RECORD PLANS

PROPOSED IMPROVEMENT
 BRIDGE PROJECT

PROJECT NAME: MENDON
PROJECT NUMBER: BRO 1443(43)

STA. 51+00 TO STA. 51+60

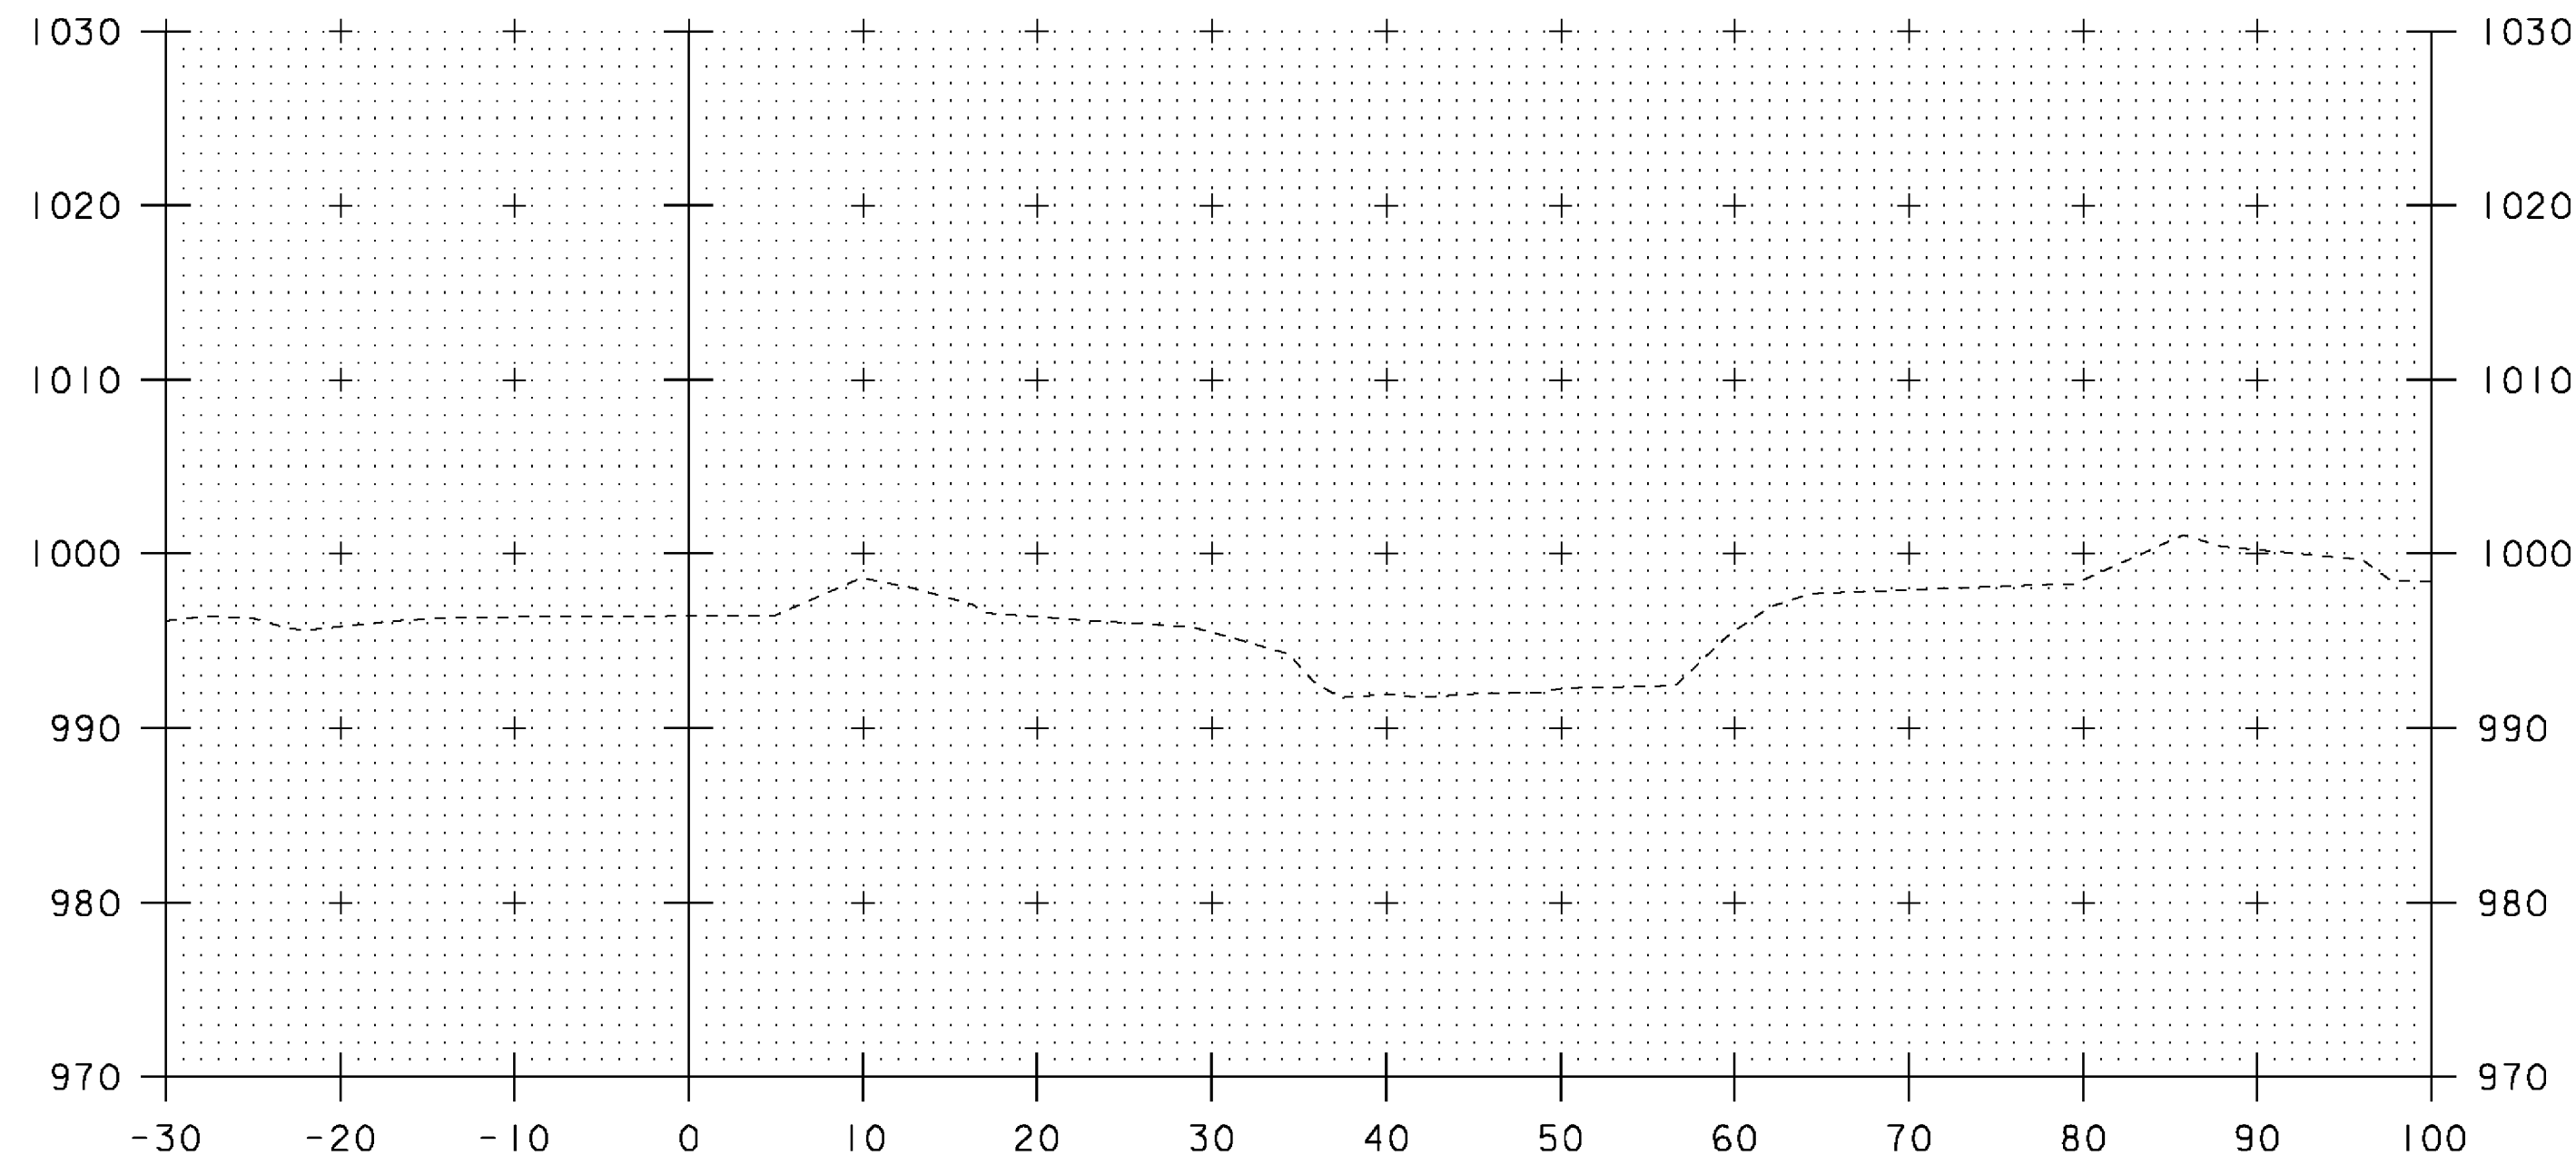
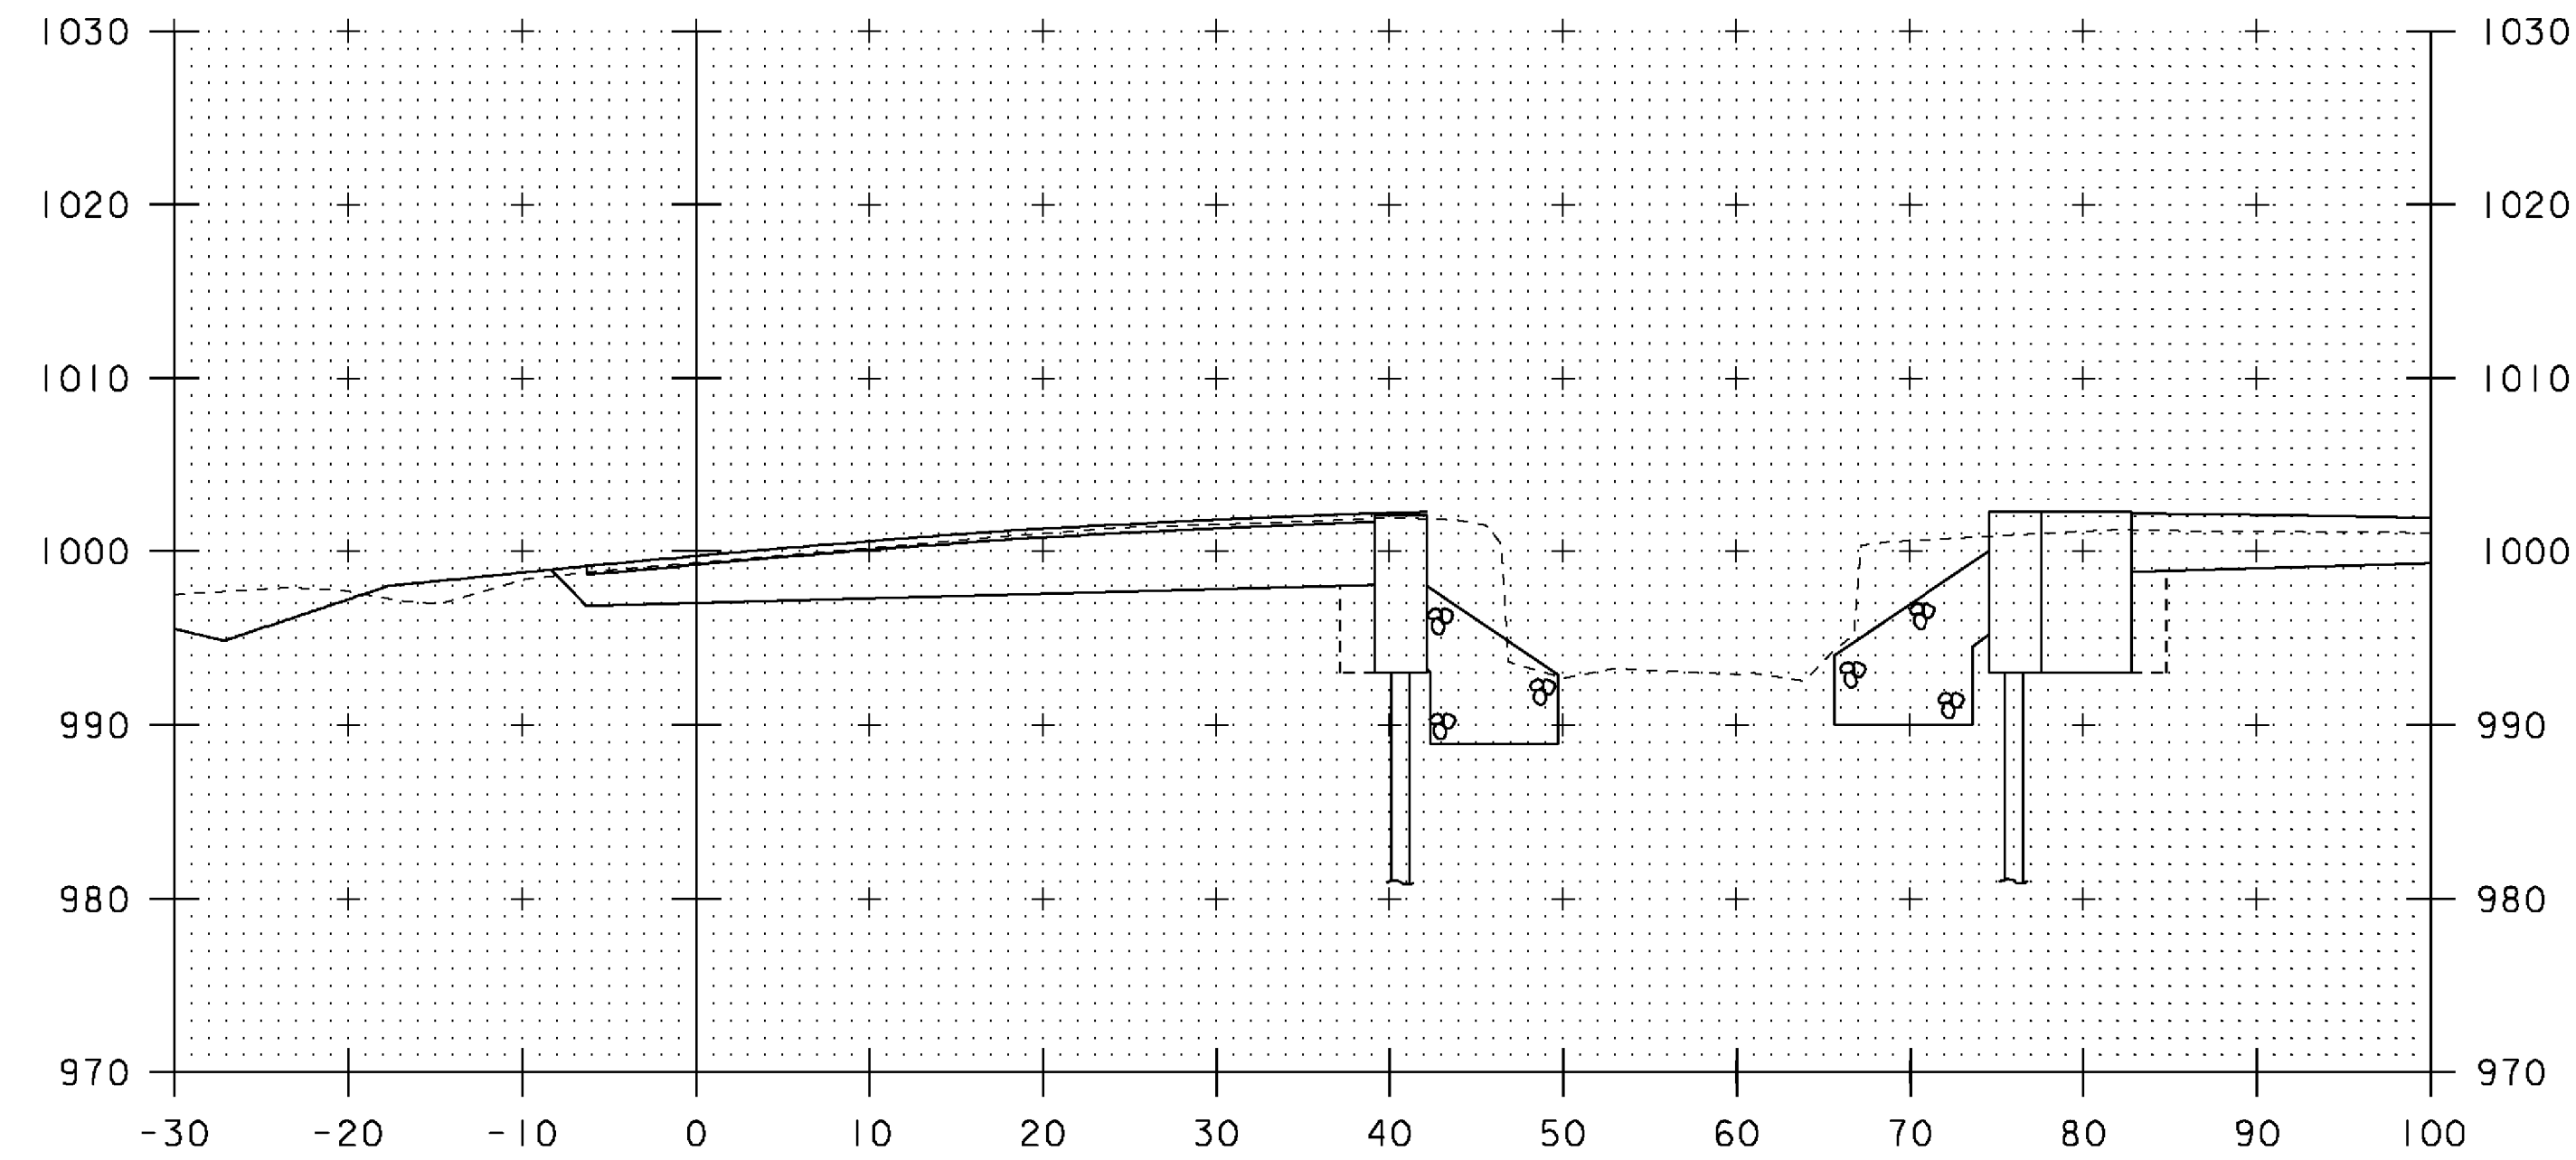
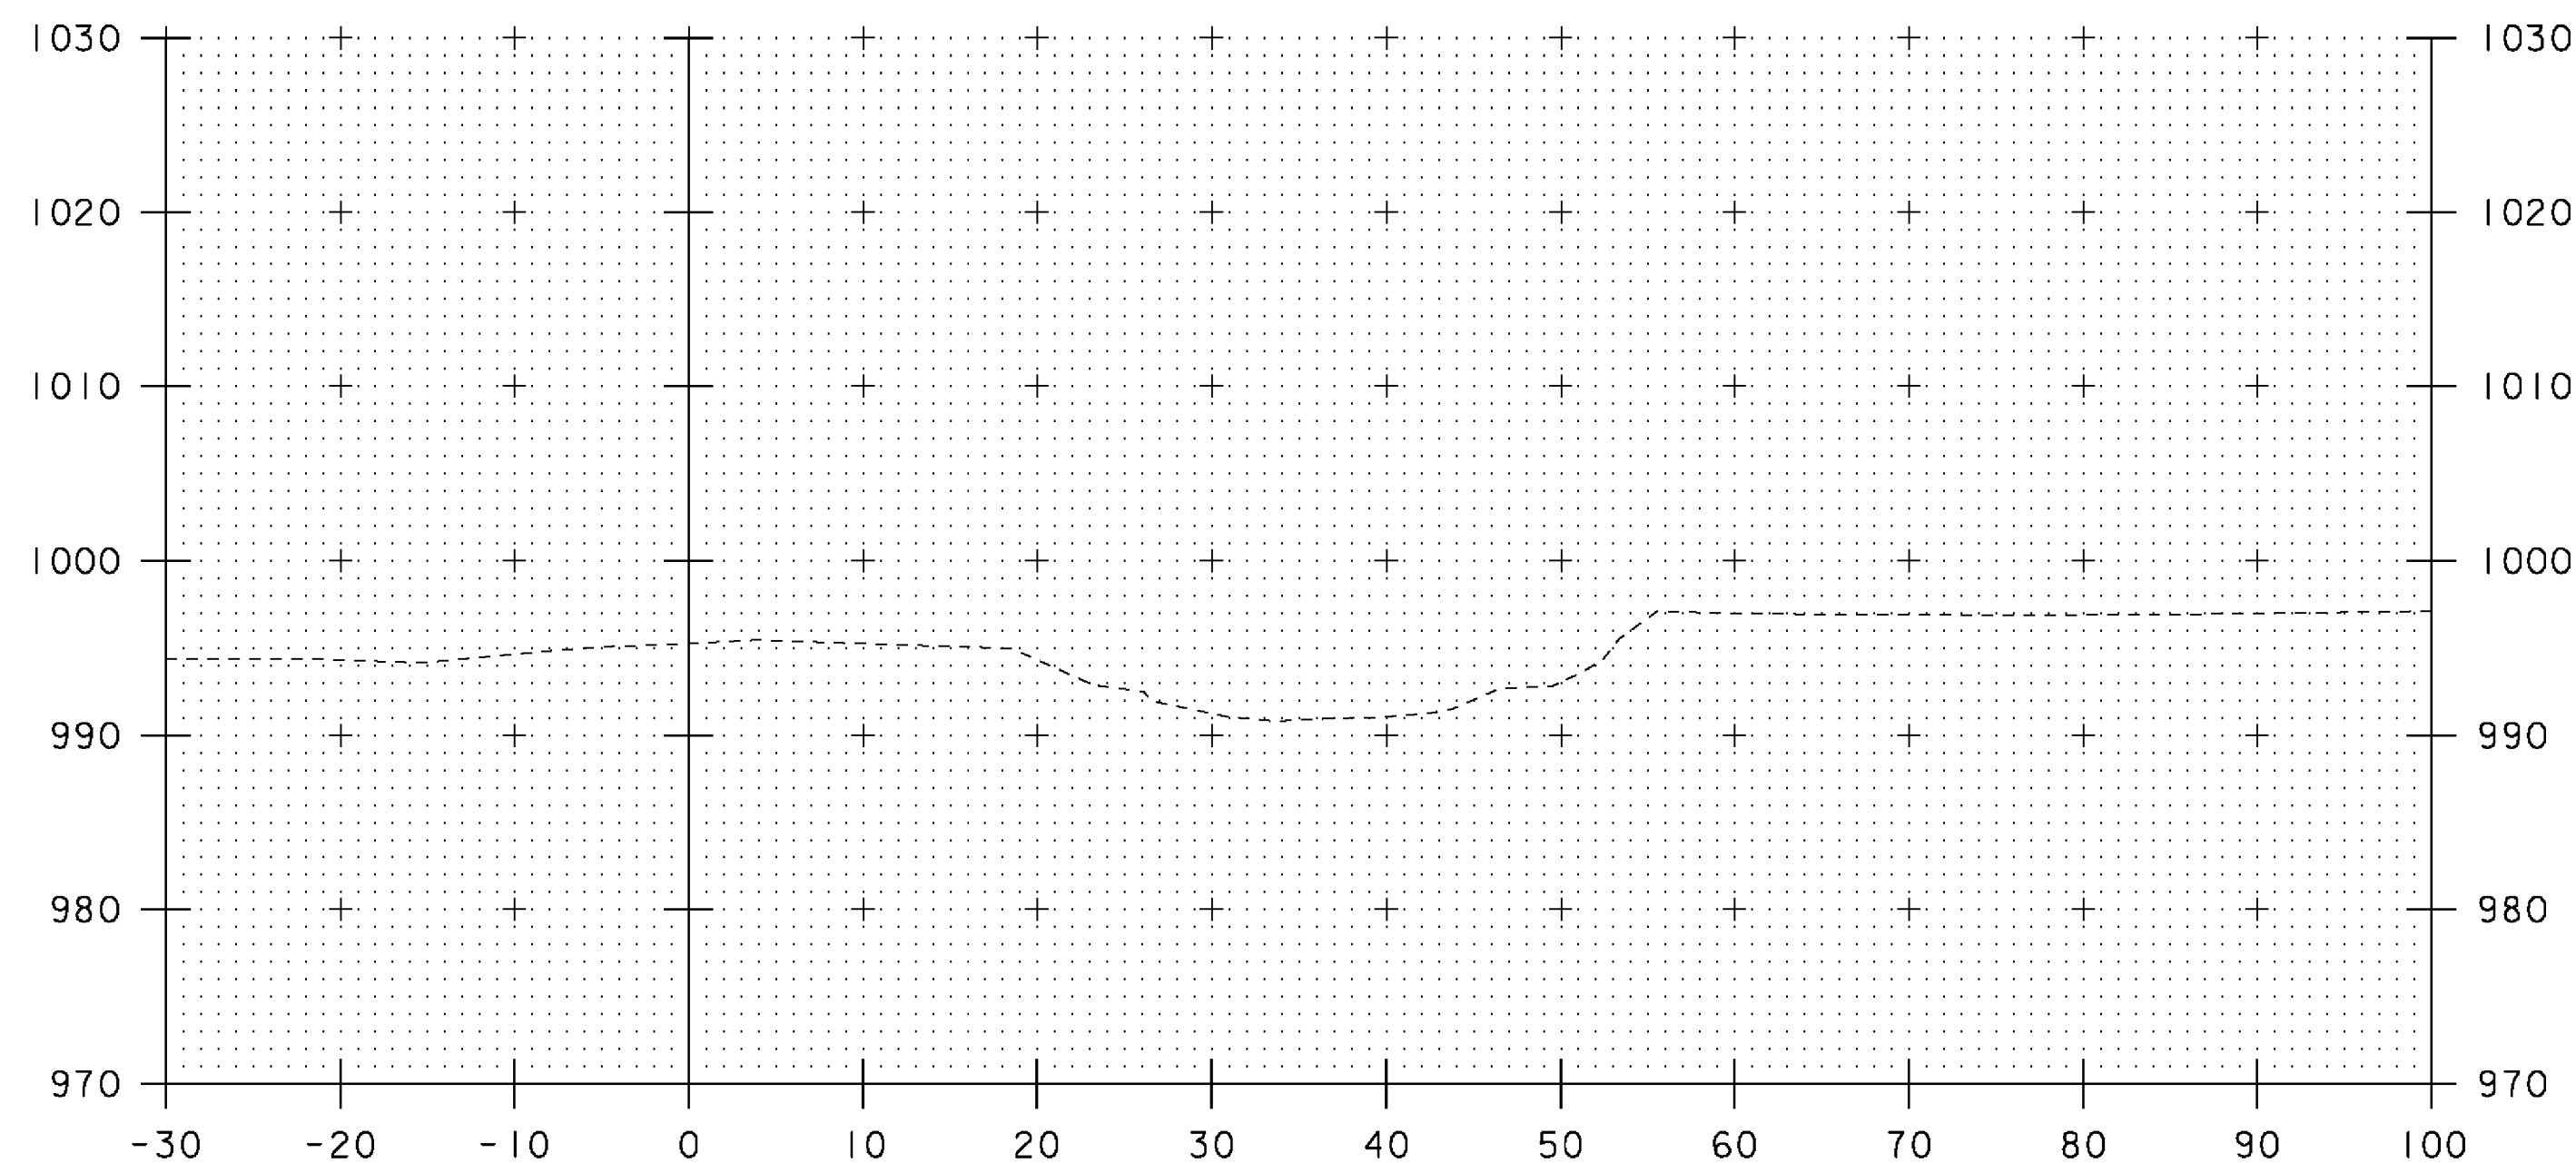
EXISTING GROUND NO LONGER VALID SINCE IRENE 8-28-11.
 NEW SURVEY REQUIRED FOR CHANNEL SECTIONS
 (TYP ALL SHEETS 31 & 32).
